DEVELOPMENT OF PARCEL 8 AND 8A DESIGN REVIEW RESPONSE

I-195 Redevelopment District

Prepared for: The I-195 Redevelopment Commission

Date of Design Review: November 9, 2022

ACCESS PLAN

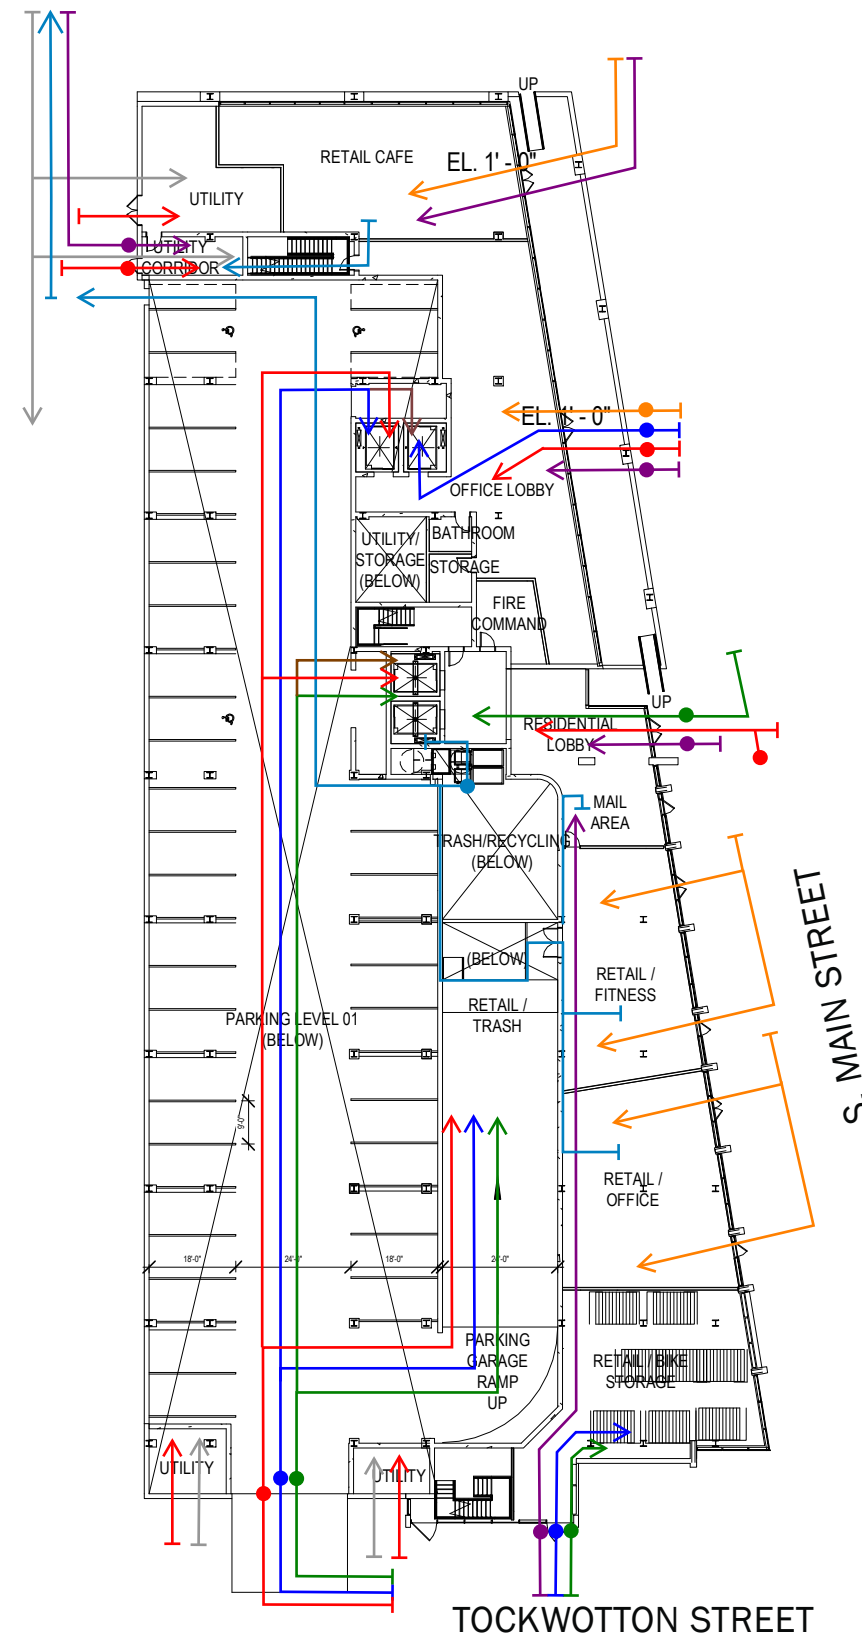
It would be helpful to understand how delivery and receiving is handled

11/09:

Delivery and receiving for the north retail and office will happen both through the Utility Corridor and through the front entrances. Delivery and receiving for the south retail will happen at the secondary entrance at the corner of South Main Street and Tockwotton.

Trash and recycling will be deposited into dumpsters outside at the north end of the parking. The south end retail will be collected at a central location internal to the building, accessed through a back-of-house corridor and brought to the north side dumpsters for removal.

PARCEL PLAN

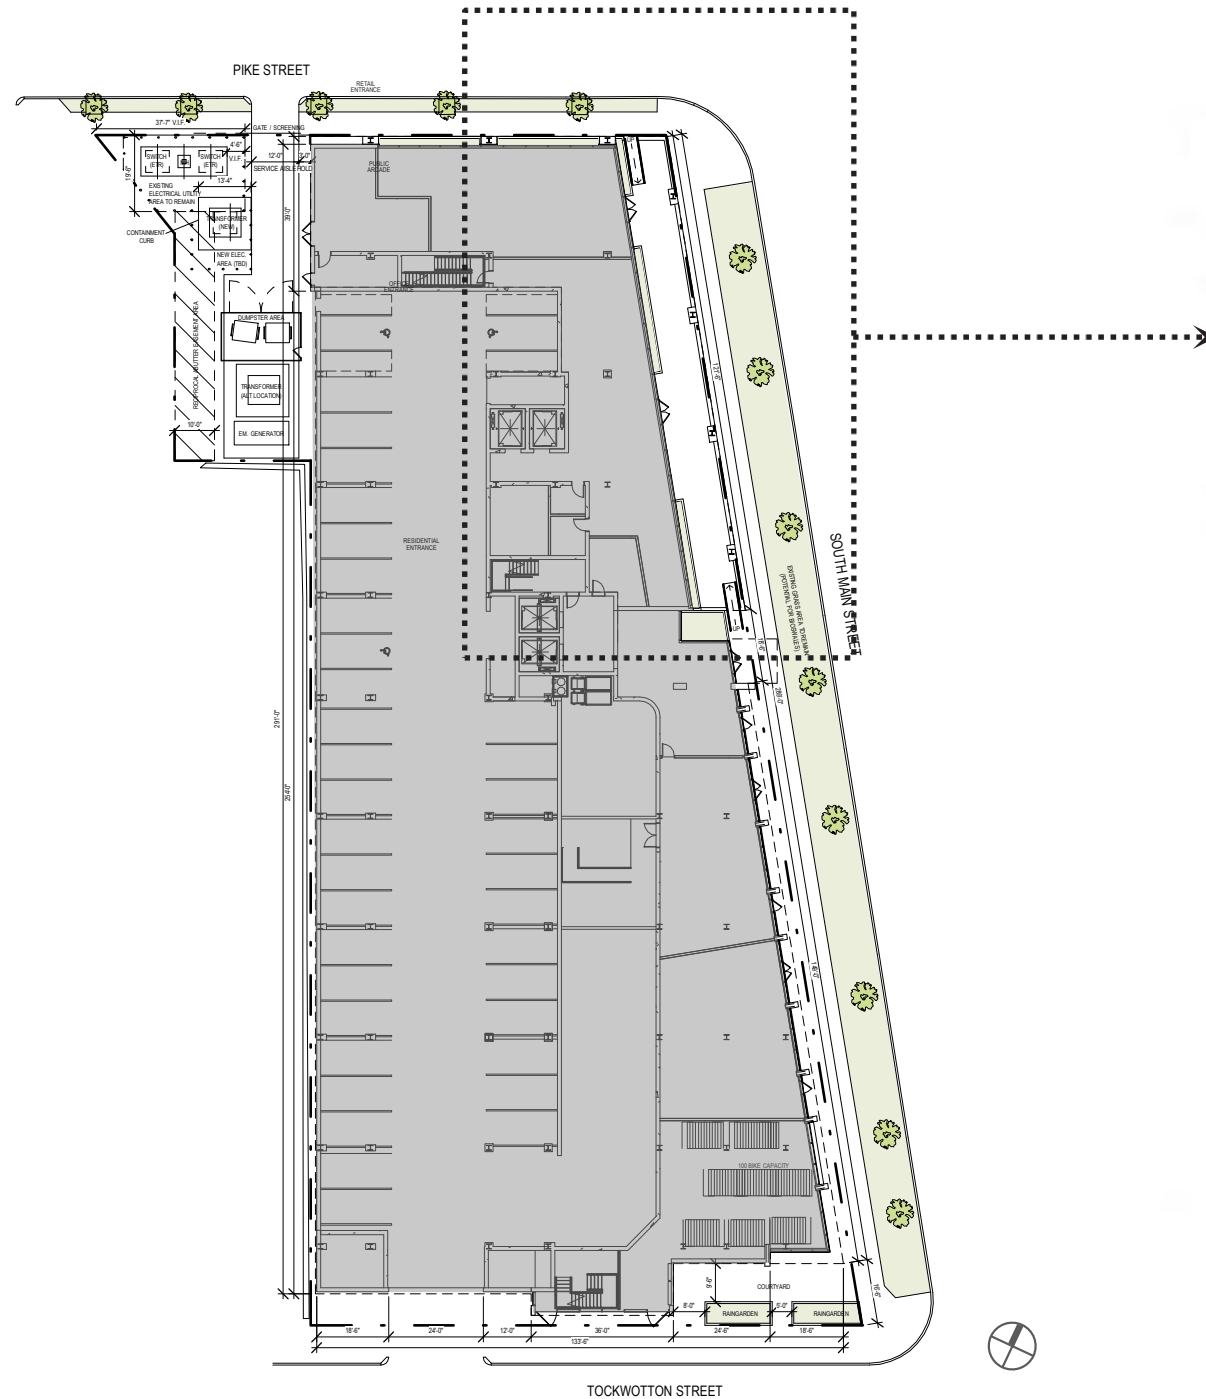
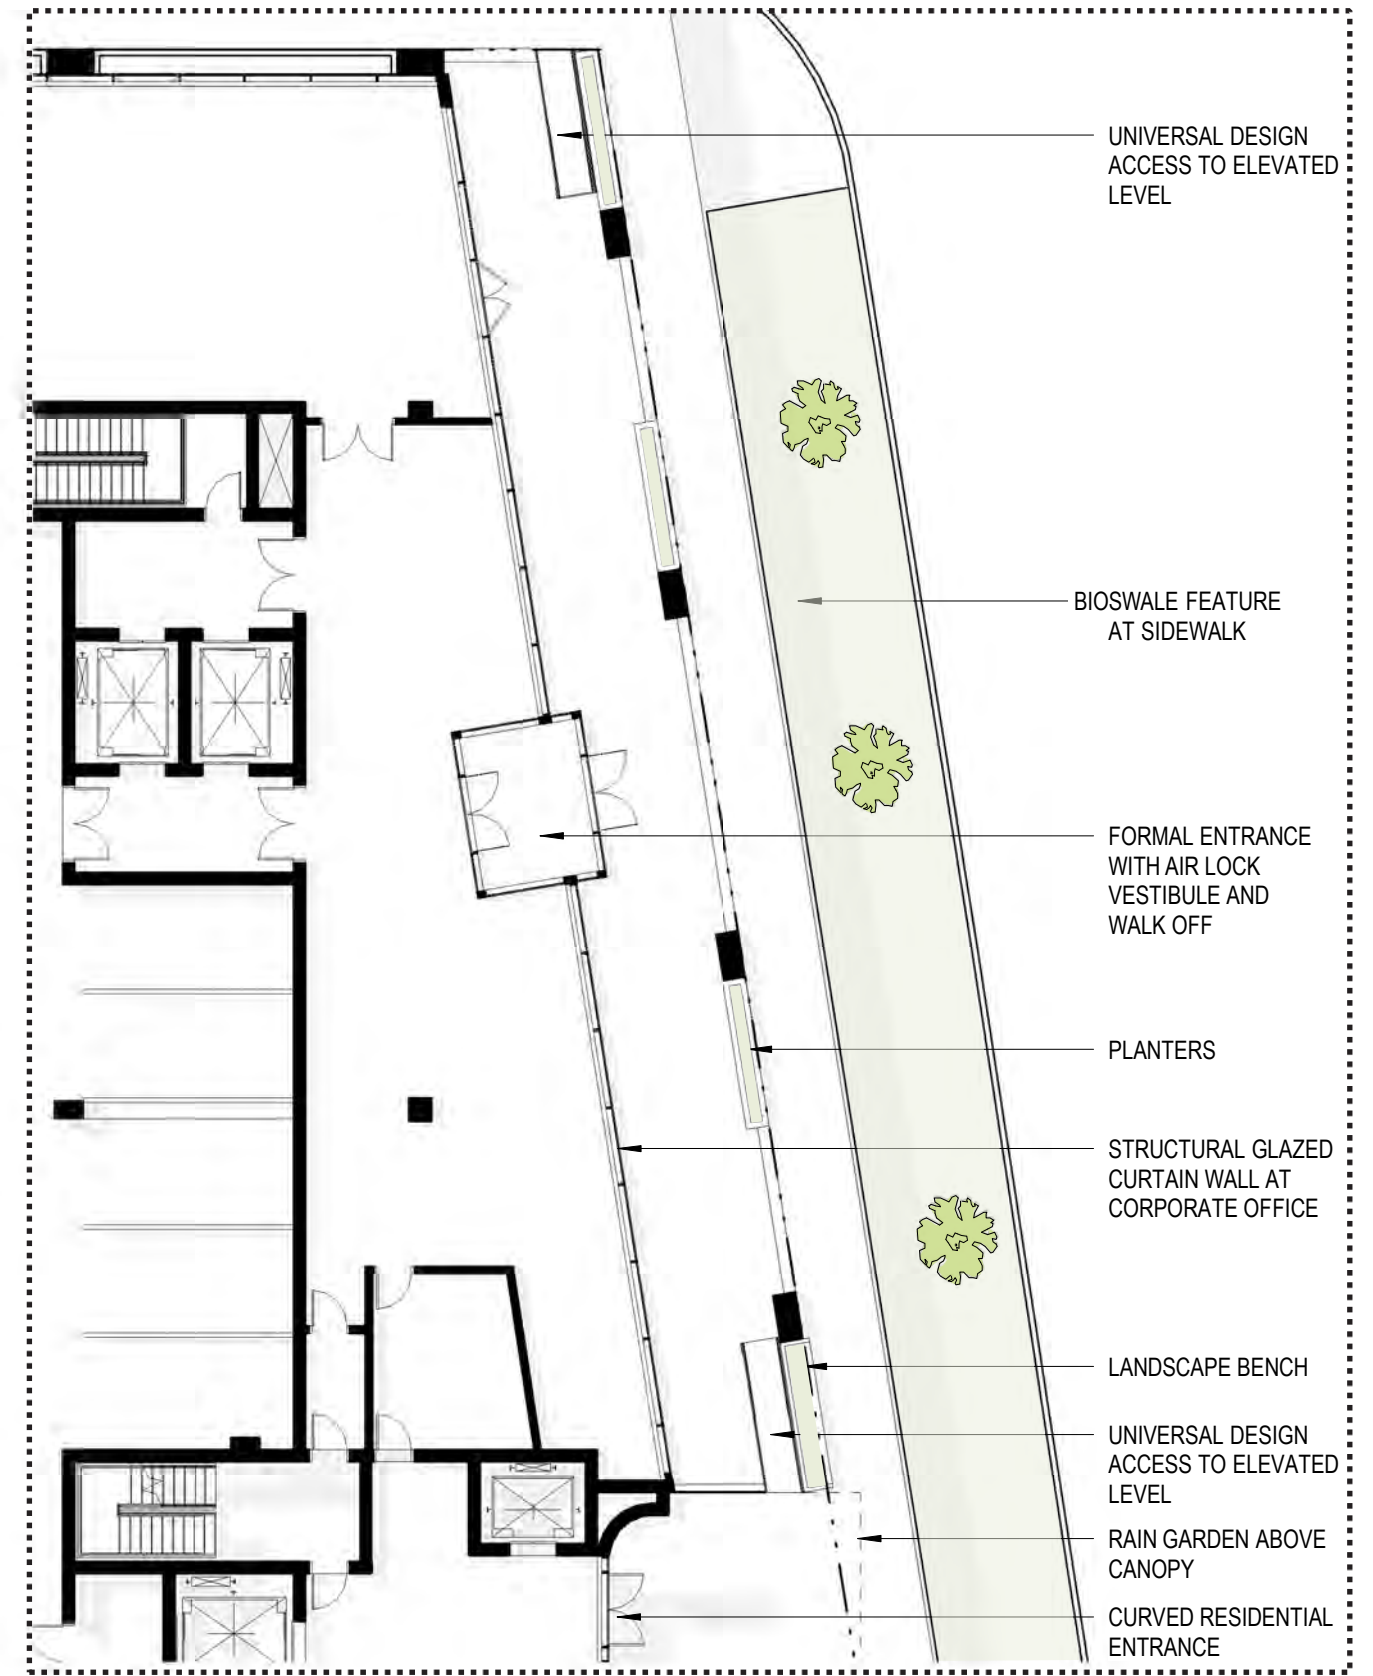
Office lobby would benefit from being more visible from the street.

Ground floor revisions introduce universal design access, to the elevated level, as a formal entrance at the prominent North-East Corner. An air-lock vestibule centered between piers creates a formal entrance to the office lobby, complete with inset walk-off mat, as per LEED requirements. Existing grass areas and landscaping are to remain at street level, along with new planters engaging the piers. Structural glazed curtain wall to remain as a glass plane for the corporate office. New ramp location and landscape bench provide residential seating and waiting area under canopy. Rain garden with native plantings is now relocated above the canopy. Rain garden with native plantings is now relocated above the canopy.

NARRATIVE REFERENCE: 1.2

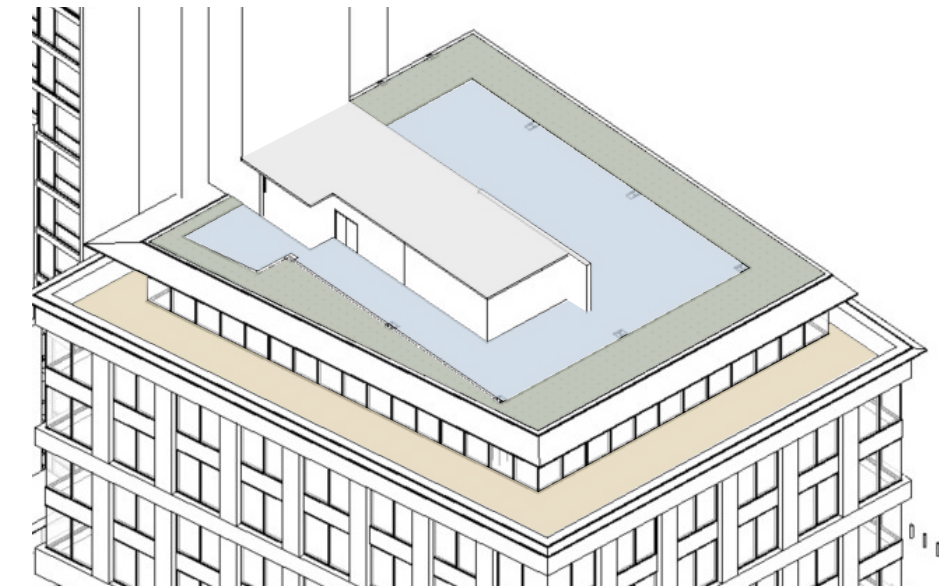
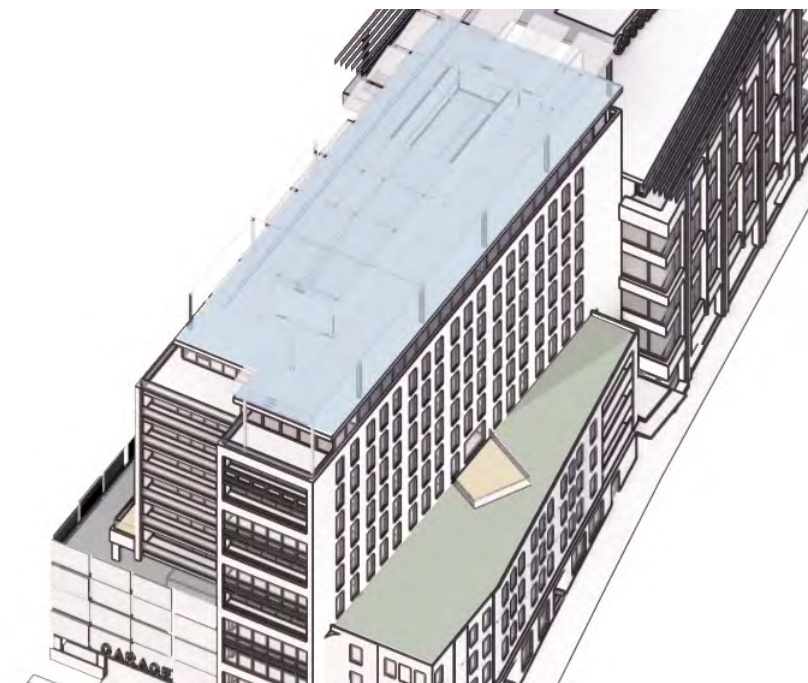
It would be helpful to understand rooftop uses at setbacks as well as study the relationship of roof planes.

- The roof of the parking deck accommodates private terraces, see the enclosed View Corridor Diagram.
- Other low roofs are occupied by green extensive roof surfaces and blue roof storm water detention systems.
- Upper roof area of the tower will be a blue roof with potential for a PV array.

ARCADE & OFFICE FACADE DESIGN

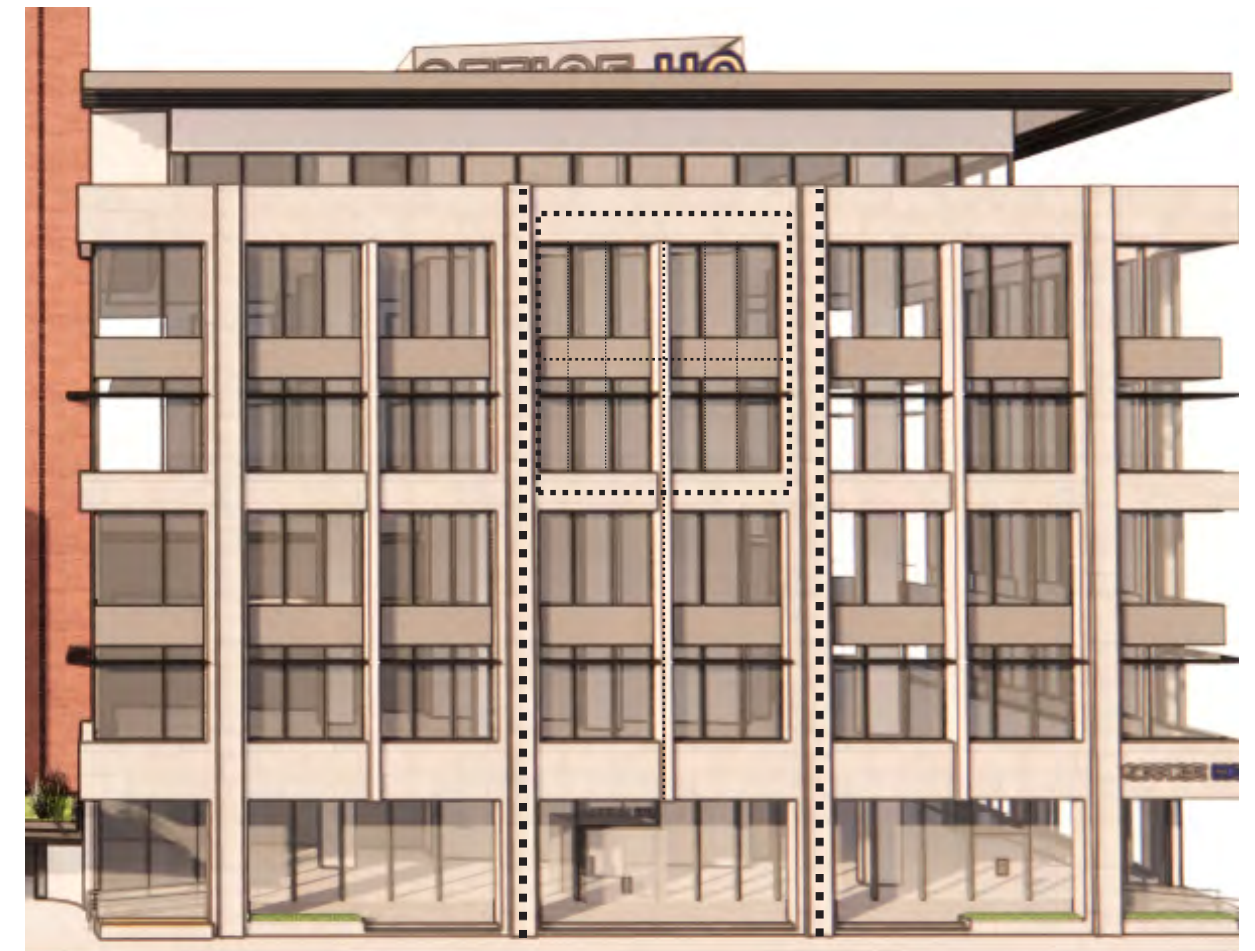
1. *While the arcade adds depth to the building elevation at street level, we are not convinced that a northeast-facing arcade is justified...the arcade terminates awkwardly on its southern end.*

2. *We suggest...a more vertical emphasis to the implied structural grid to make the office building seem less compressed.*

3. *The exaggerated curved cornice of the office building makes the building feel squat. We suggest a smaller scale cornice profile...*

We have maintained the arcade as a multi-functioning element not strictly related to shading conditions. It provides a relief at the street for inclement weather and a formal walking path along the front of the office building that will be well-lit. This provides a space where the massing of the building does not look so heavy; it floats the mass and is complimented by the step-back at the penthouse level.

The Design Team has reduced appearance of large squares on the office building by introducing articulations to the vertical elements. For instance, by introducing curves and profiles that create a dynamism in the curving of the vertical flute the overall form is elongated. The curved vertical flute references water and fluidity, an idea inspired by nature in and around Providence. Additionally, the facade incorporates levels of depth which can be read in the diagram below showing the different orders. The 4th order is another example, which are mullions which divide the windows into long, rectangular sections. This is an effort to break down the form and accentuate its verticality.

The Design Team has minimized the cornice and refined the canopy at the sixth floor to have a better relationship with the overall volume of the building.

SOLAR STUDY

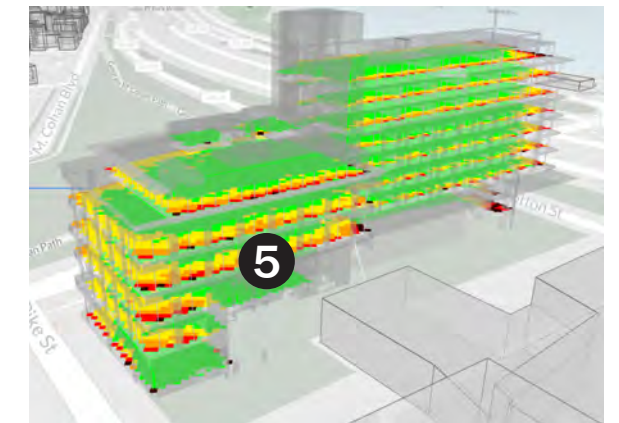
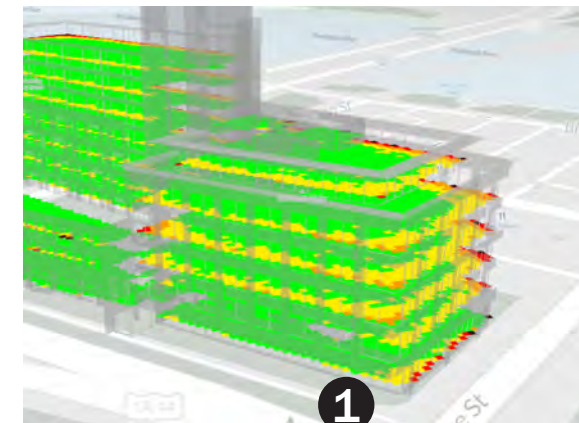
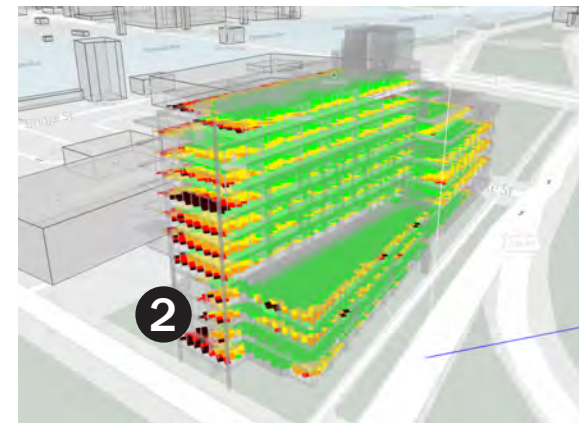
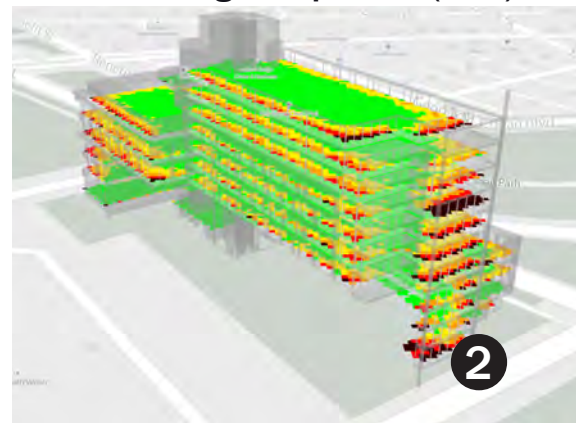
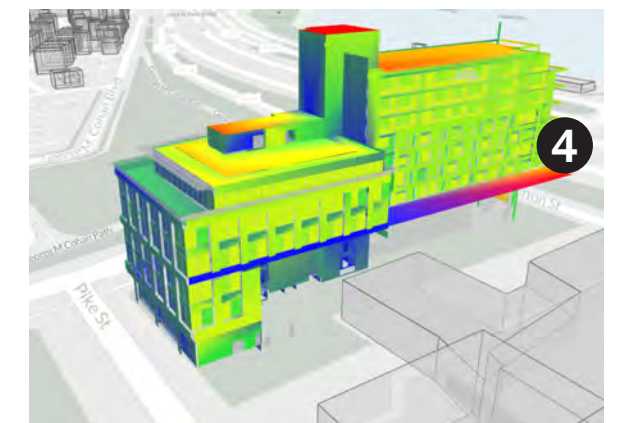
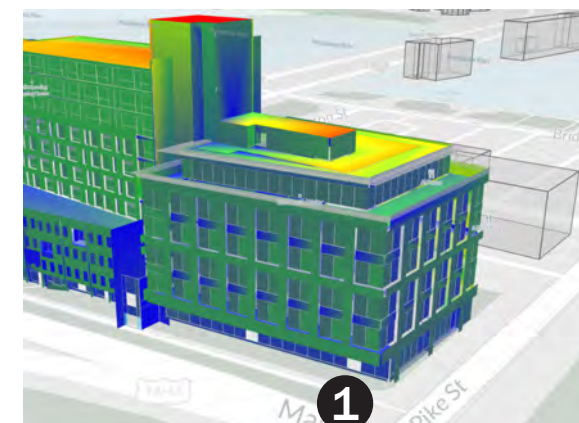
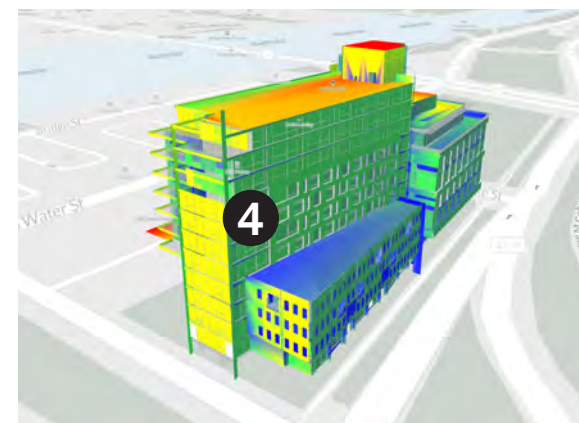
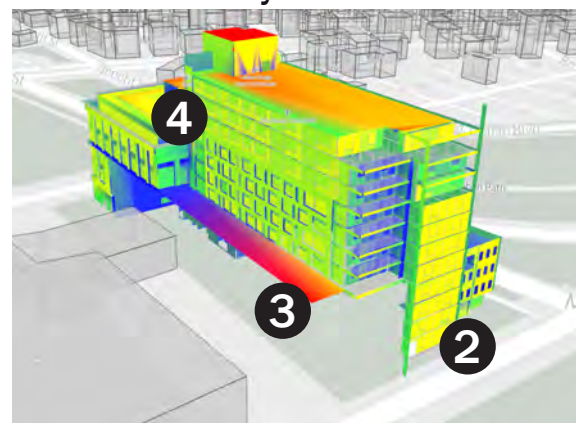
11/09: Using Cove Tool, we conducted an ASE and Sun Hours study to better understand how we can improve the building based off the previously-submitted building massing and facade material selection.

- 1** The arcade: this reinforces the idea that the arcade is not to provide solar protection, but rather, to serve as a shelter in inclement weather for building users as they enter the office.
- 2** The South facade receives excessive amounts of solar exposure, so changing the facade type to allow for more shading is beneficial in this area.

- 3** The suggestion of having the roof of the parking become usable will be incorporated into the design and will allow residents with another spot to enjoy the sunlight.
- 4** The residential tower no longer has the glazing as proposed before due to the results of these studies. Rather, punched window openings will provide

- some of the much-needed solar protection, particularly on the West facade. Both the East and West facades will be treated the same to provide continuity throughout throughout the building.
- 5** The amount of glare on the West facade of the office is something we are looking to address in future updates.
